XT308-06

## TECHNICAL BULLETIN

Difficult/High Effort Engagement Into First Or  
Reverse – Clutch Disc Sticking –  
Regrease Input Splines

MODEL 2002-05 MY  
X-TYPE

ILLUSTRATION 1

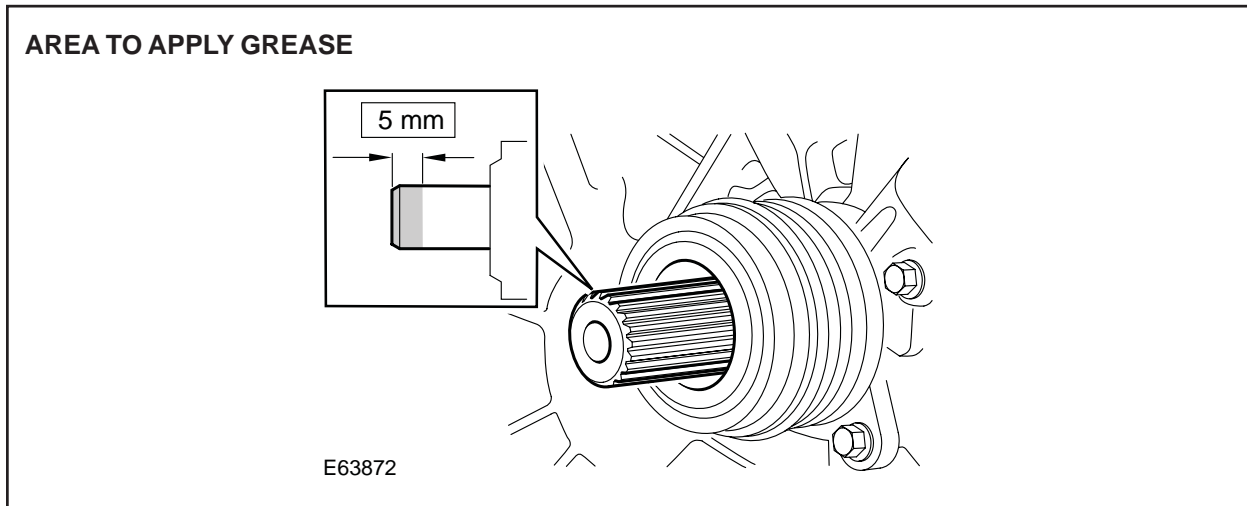
Some X-TYPE vehicles may exhibit difficulty engaging first or reverse gear, especially when the vehicle is cold. This can be caused by the clutch disc sticking on the transmission input shaft splines.

**Caution:** To much grease applied to the input shaft splines may lead to contamination of the clutch disc.

- Apply grease (specification ESD-M1C220-A or Castrol Pyroplex Red or Castrol Pyroplex Blue) to the circumference of the input shaft splines, not exceeding a length of 5 mm as shown in Illustration 1.
